ENGINE - LP COMPRESSOR - PROVIDE A NEW WEIGHT REDUCED FAN CASE ASSEMBLY - CATEGORY  
CODE 7 - MOD.ENG-72-0103

V2500-ENG-72-0103

Fan Case Assembly - Before and After Alteration  
Fig.1

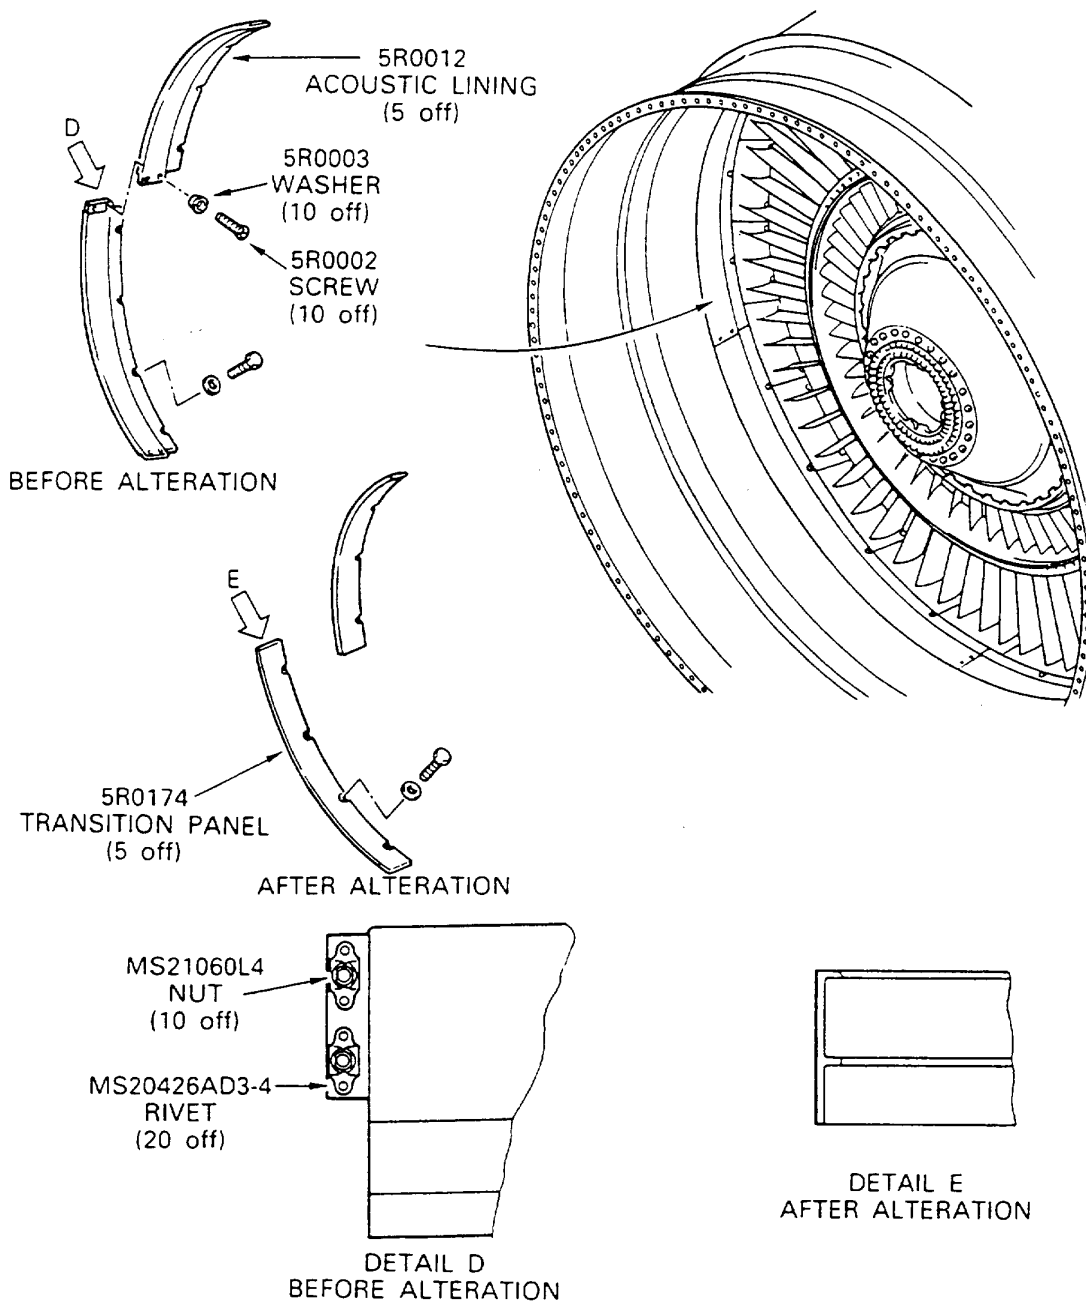
- (a) The carcase thickness of the Fan Case Assembly has been reduced accompanying with improved linings and panels. And the transition panels are applied for this new configuration (See Figures 1 and 2).

- (b) The lifting holes with bushings are provided at TDC of the Flange FD and the Flange FE on the Fan Case to improve the Fan Case maintainability (See Figure 1).

- (1) Assemble the new 5W0124, Fan Case Assembly to the LP Compressor/Intermediate Case Module by the approved procedures in the Engine Manual, 72-32-00 Assembly (Refer to 1.K. (3)).

Fan Case Fitting Parts - Before and After Alteration  
Fig.3

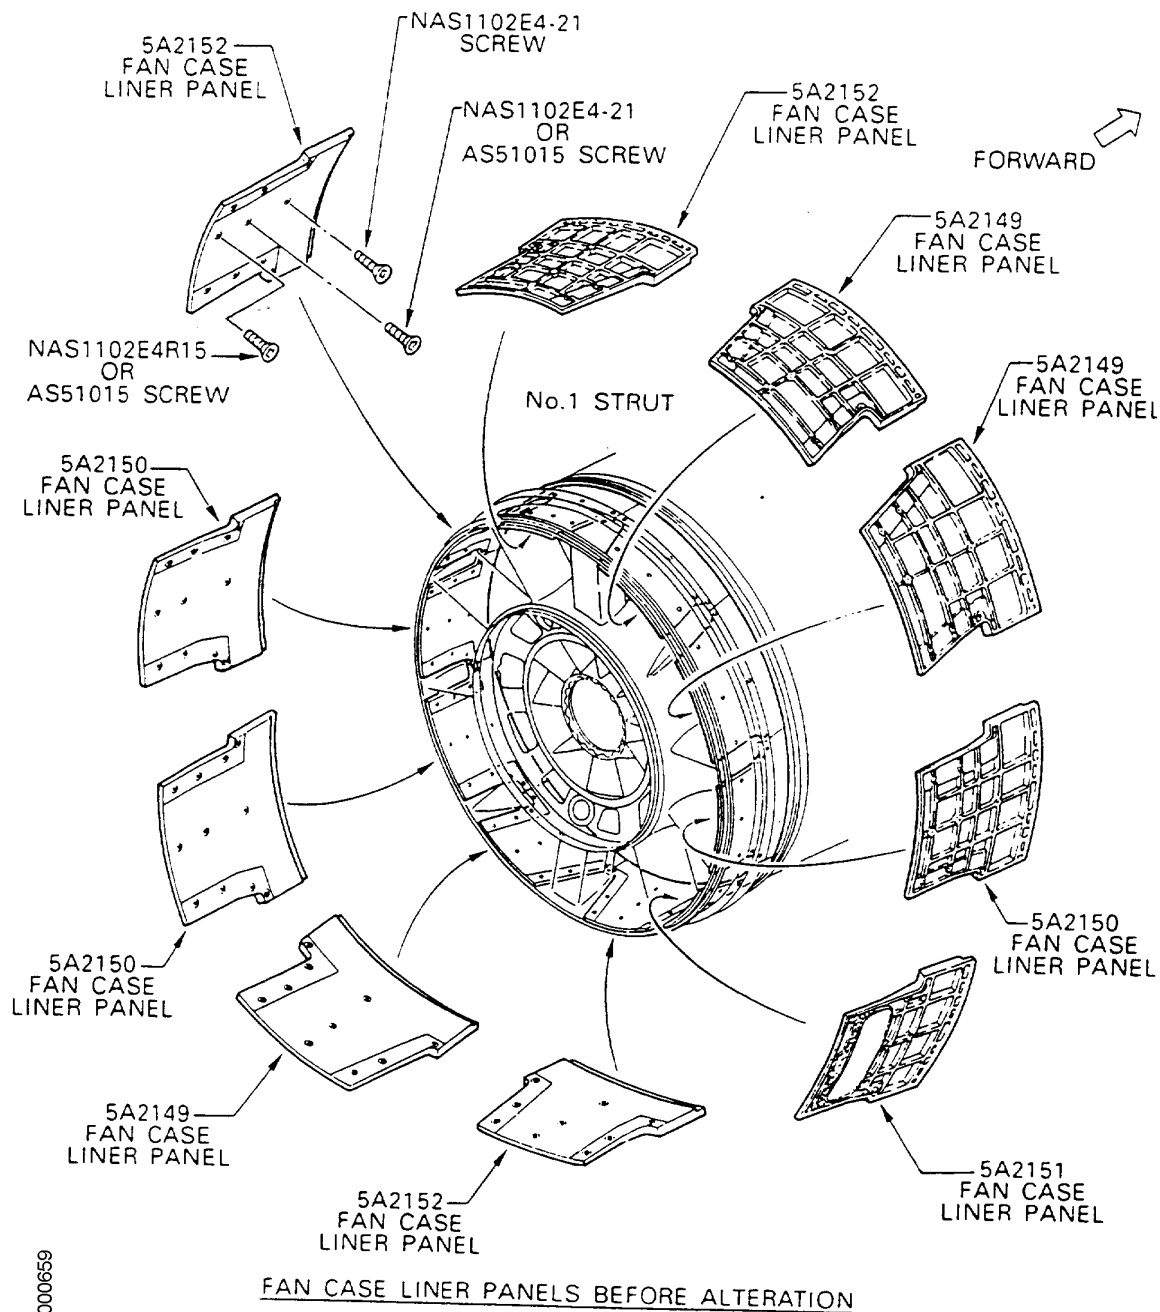
- (d) New Rubber Seals have been introduced (See Figure 5).
  - (e) With changes described in 1.D. (1) (c) and (d), quantity and location of the fastening features of the Rubber Seals and the Fan Case Liner Panels to the Fan Case Assembly have been changed (See Figures 3, 6 and 7).

Fan Case Liner Panels - Before and After Alteration  
Fig.4, Sheet 1 of 2

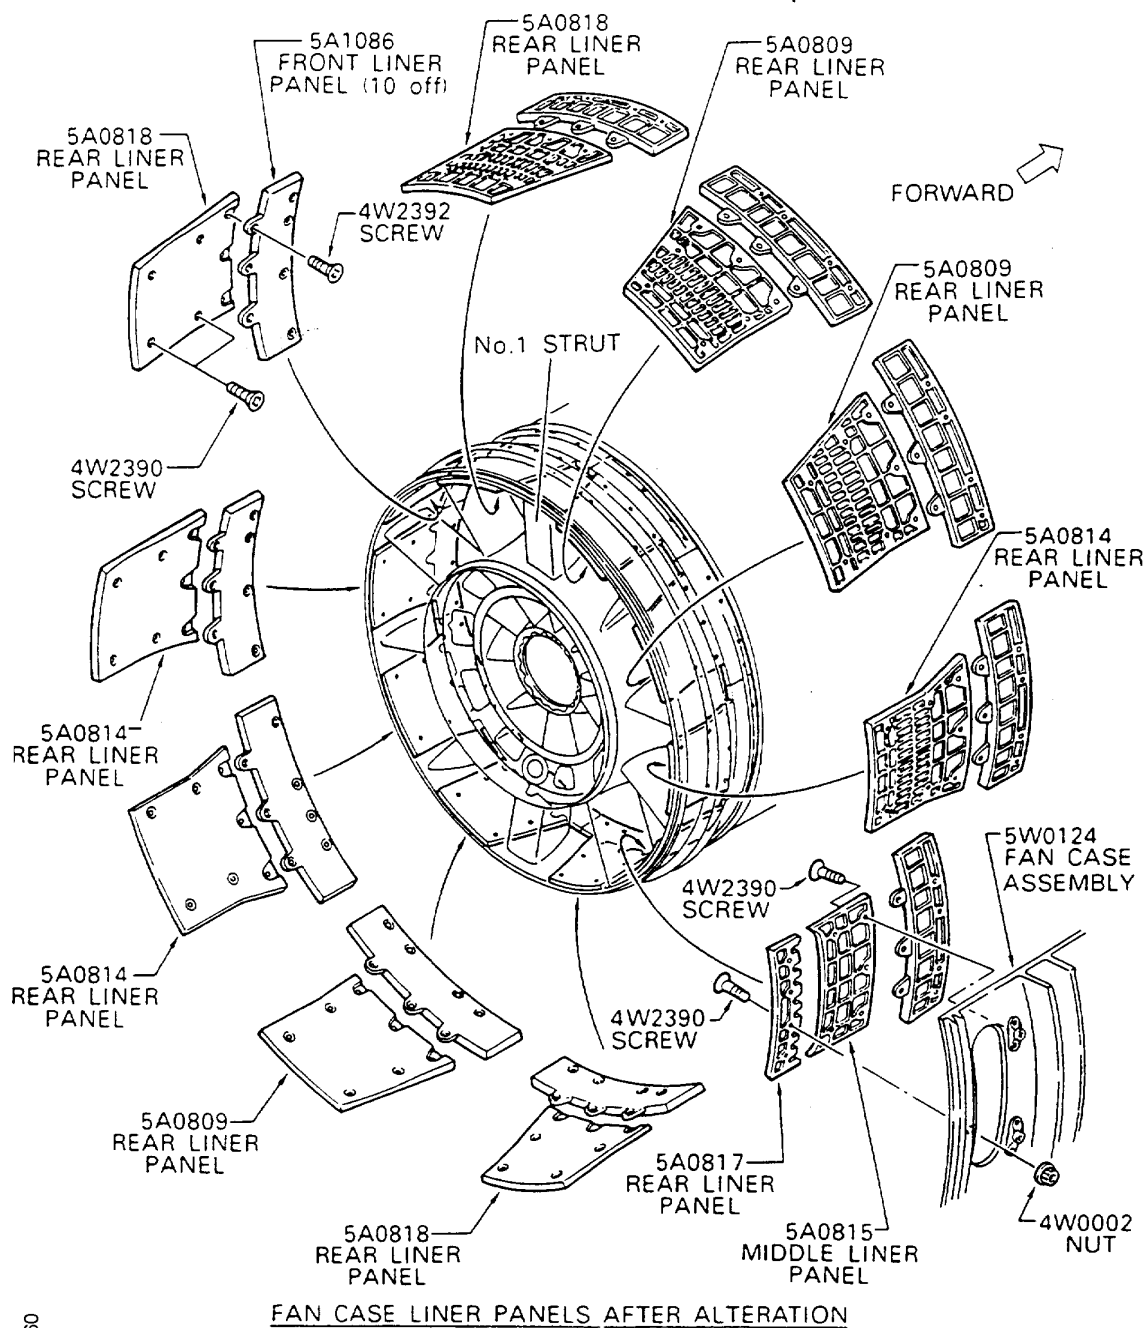
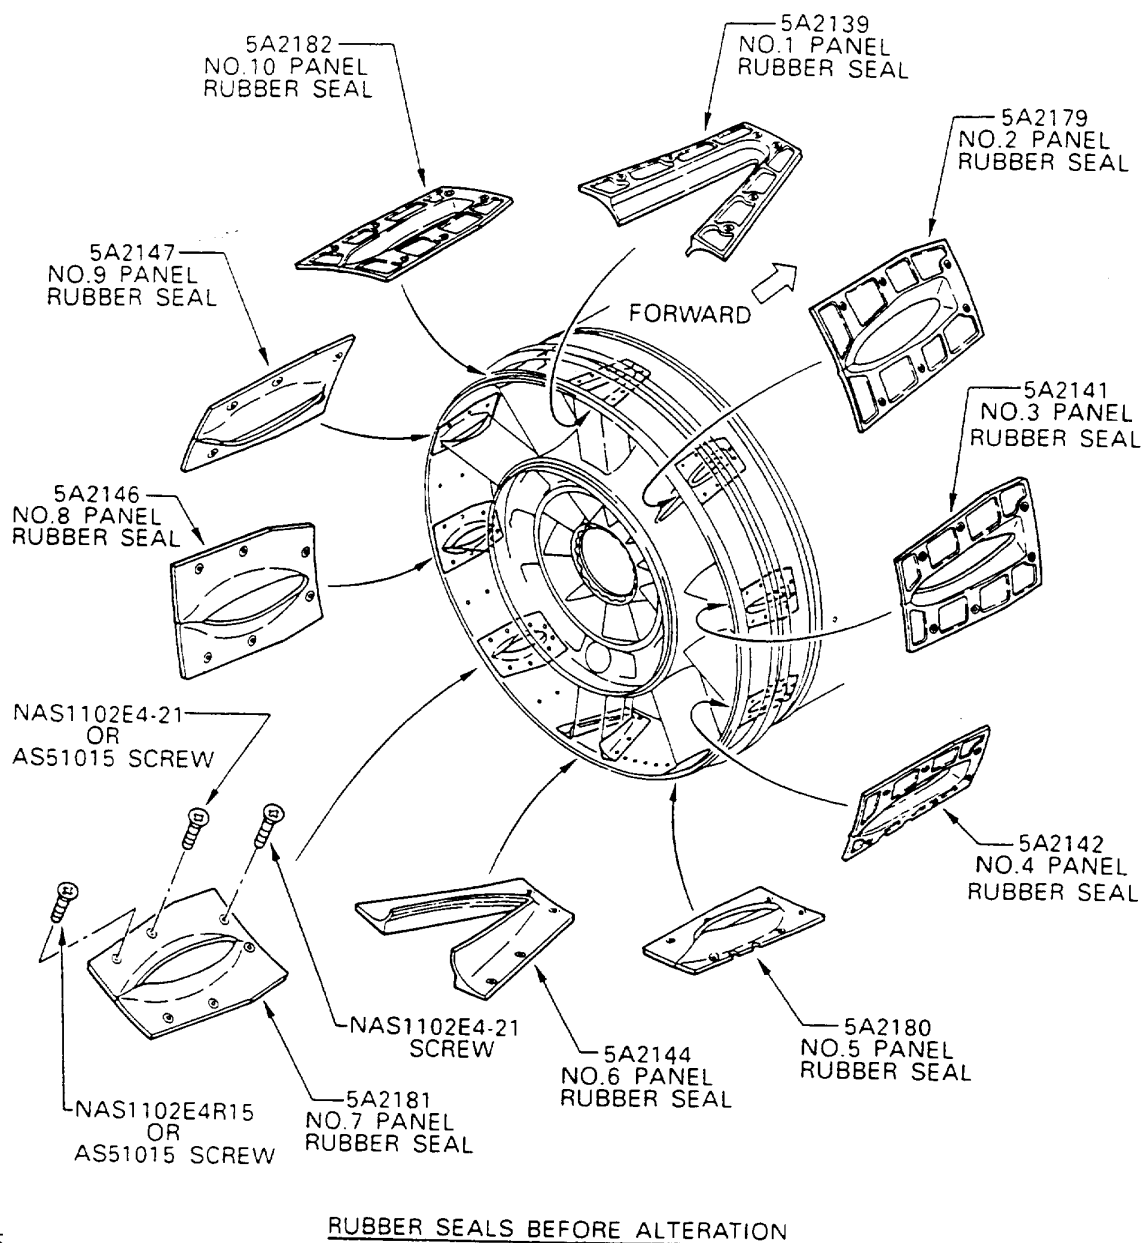
- (c) Each of Fan Case Panel Liners has been divided into two pieces (i.e. Front and Rear) to improve the maintainability and also the material of liners has been changed to increase the impact strength against Foreign Objective Damage (FOD) (See Figure 4).

- (2) Assemble the ten 5A1086, Front Liner Panels, the three 5A0809, Rear Liner Panels, the three 5A0814, Rear Liner Panels, 5A0815, Middle Liner Panel, 5A0817, Rear Liner Panel, the three 5A0818, Rear Liner Panels to the LP Compressor/Intermediate Case Module with the 30, 4W2392, Screws, the 42, 4W2390, Screws, and the four 4W0002, Nuts by use of approved procedures in the Engine Manual 72-32-00, Assembly (Refer to Figure 3, Figure 4, Sheet 2, Figure 6, Sheet 2 and 1.K. (3)).

Fan Case Liner Panels Attaching Screws and Nuts - Before and After Alteration  
Fig.6, Sheet 1 of 2

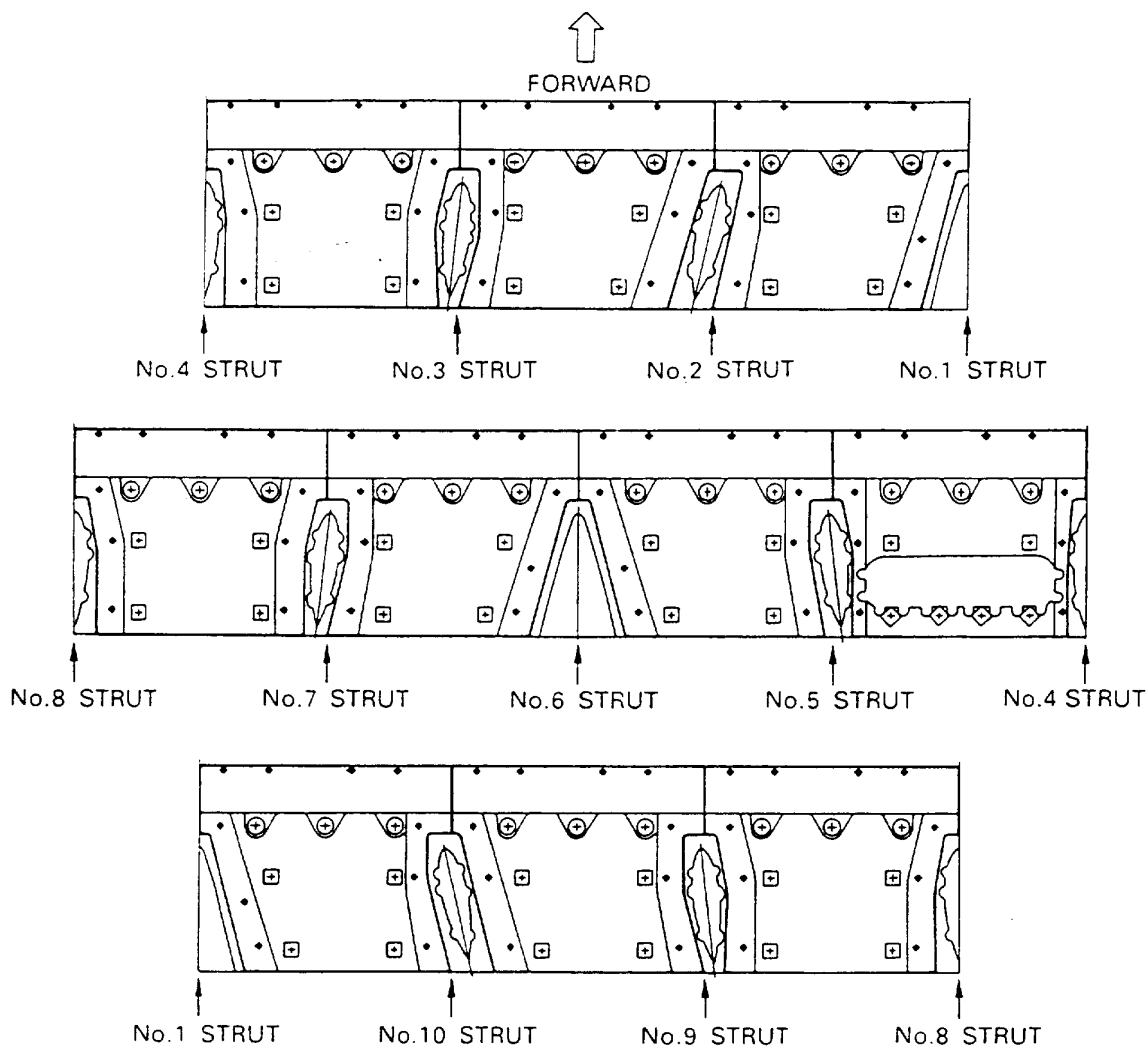
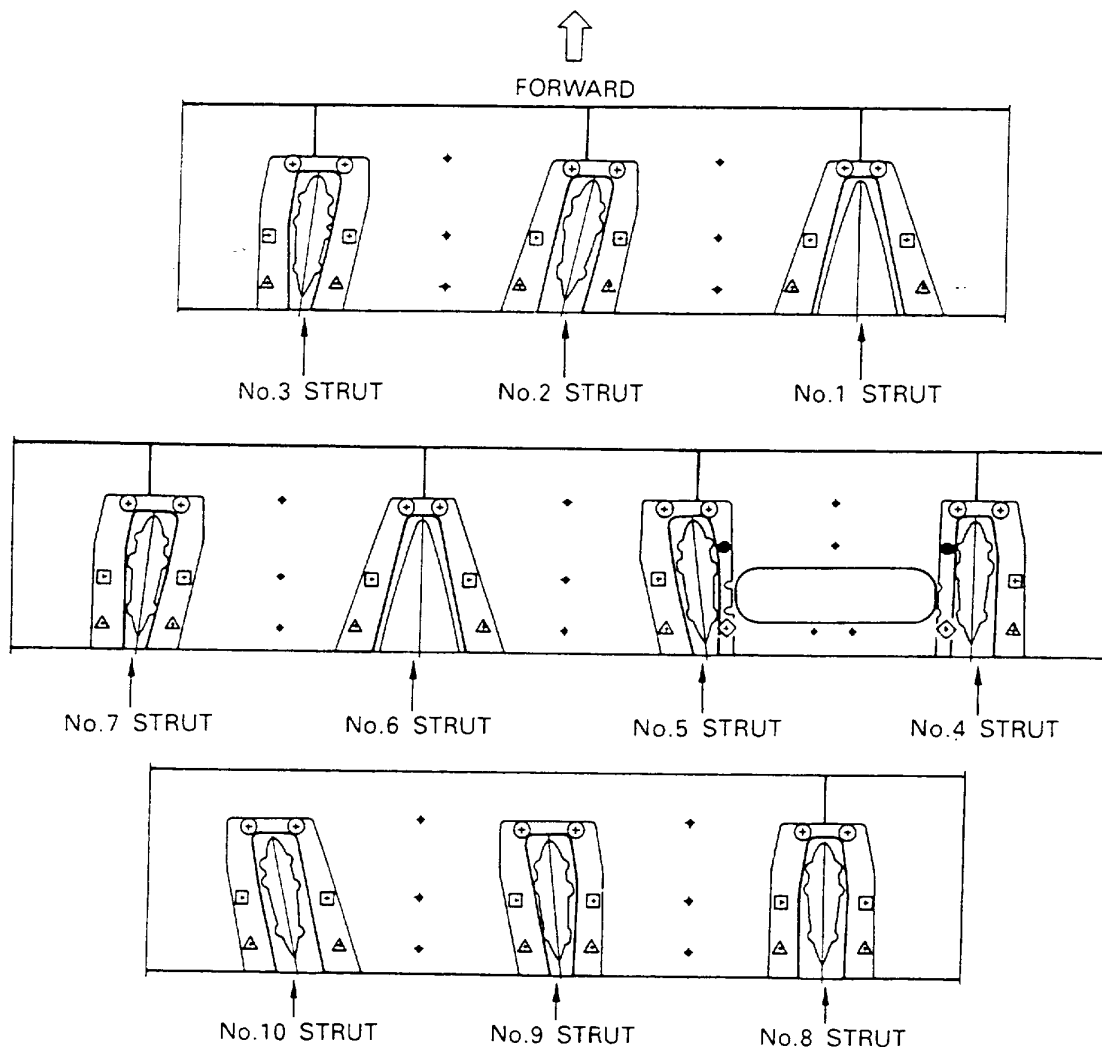
POSITION OF FAN CASE LINER PANELS ATTACHING SCREWS AND NUTS-BEFORE ALTERATION

POSITION OF FRONT AND REAR LINER PANELS ATTACHING SCREWS AND NUTS - AFTER ALTERATION

Rubber Seals Attaching Screws and Nuts - Before and After Alteration  
Fig.7, Sheet 1 of 2

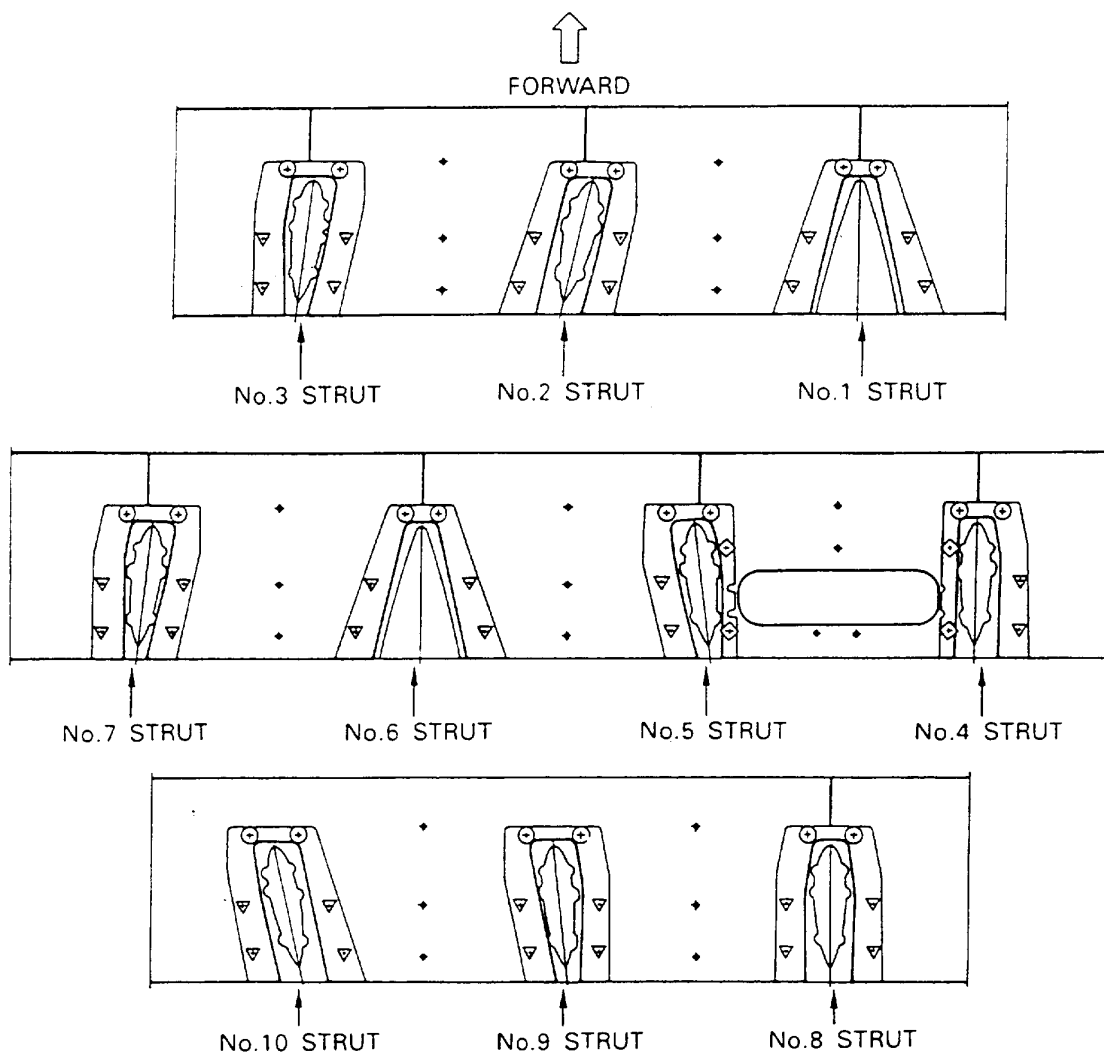
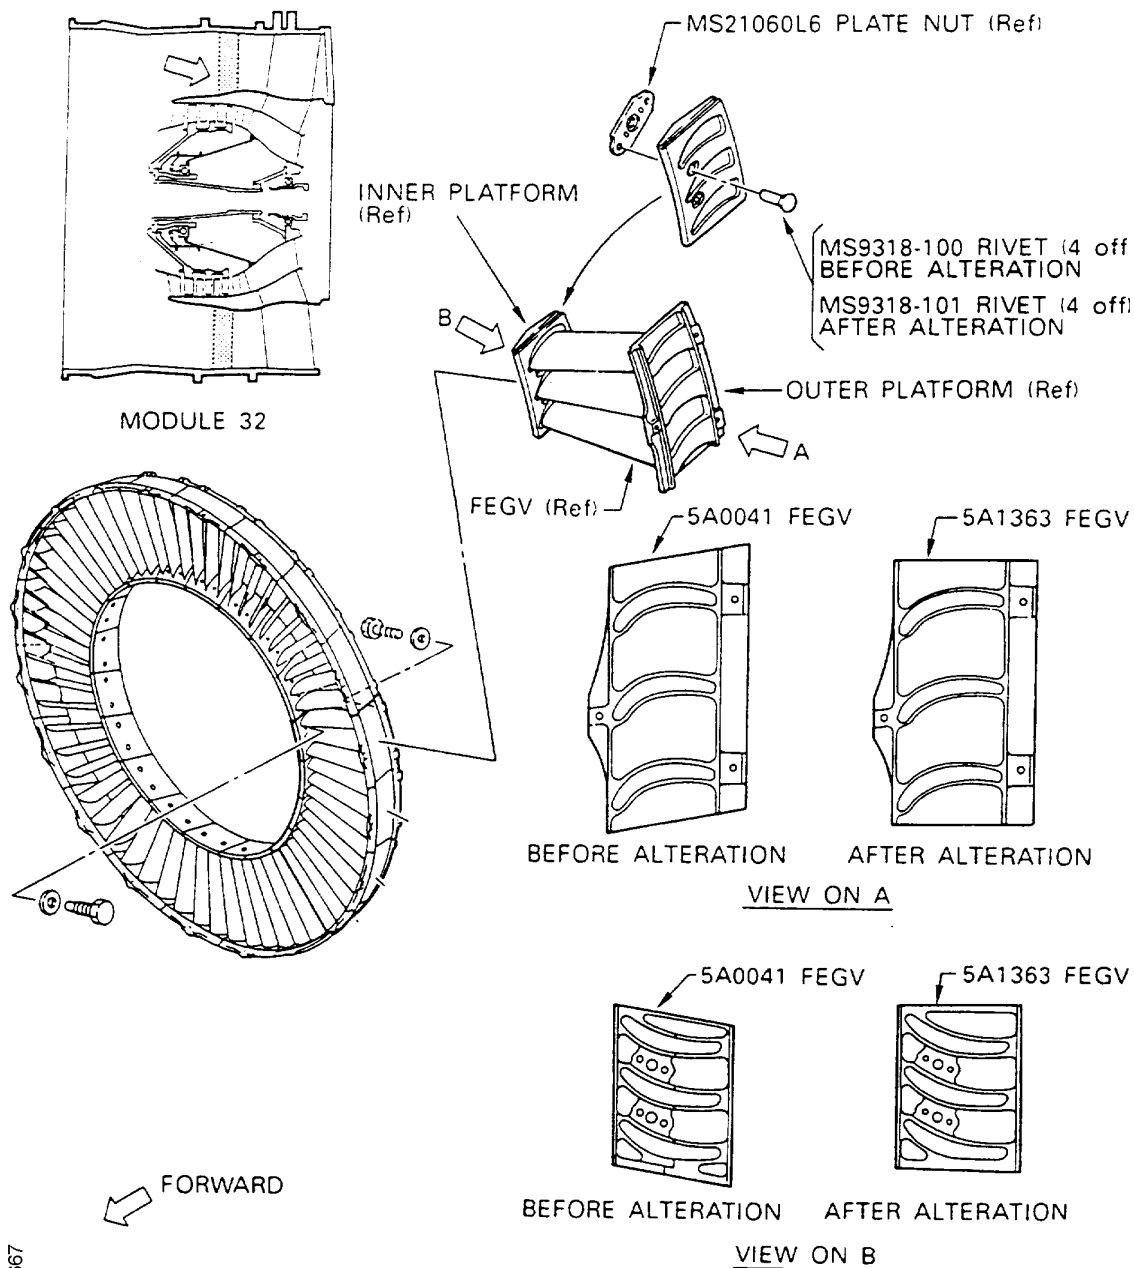
POSITION OF RUBBER SEALS ATTACHING SCREWS AND NUTS - BEFORE ALTERATION

POSITION OF RUBBER SEALS ATTACHING SCREWS AND NUTS - AFTER ALTERATION

- (3) Assemble 5A0819, Rubber Seal, 5A0823, Rubber Seal, 5A0824, Rubber Seal, 5A0825, Rubber Seal, 5A0827, Rubber Seal, 5A0828, Rubber Seal, 5A0829, Rubber Seal, 5A0830, Rubber Seal, 5A0831, Rubber Seal and 5A0832, Rubber Seal to the LP Compressor/Intermediate Case Module with the 20, 4W2392, Screws, the 40, 4W2390, Screws, and the four 4W0002, Nuts by use of approved procedures in the Engine Manual 72-32-00, Assembly (Refer to Figure 3, Figure 5, Sheet 2, Figure 7, Sheet 2 and 1.K. (3)).
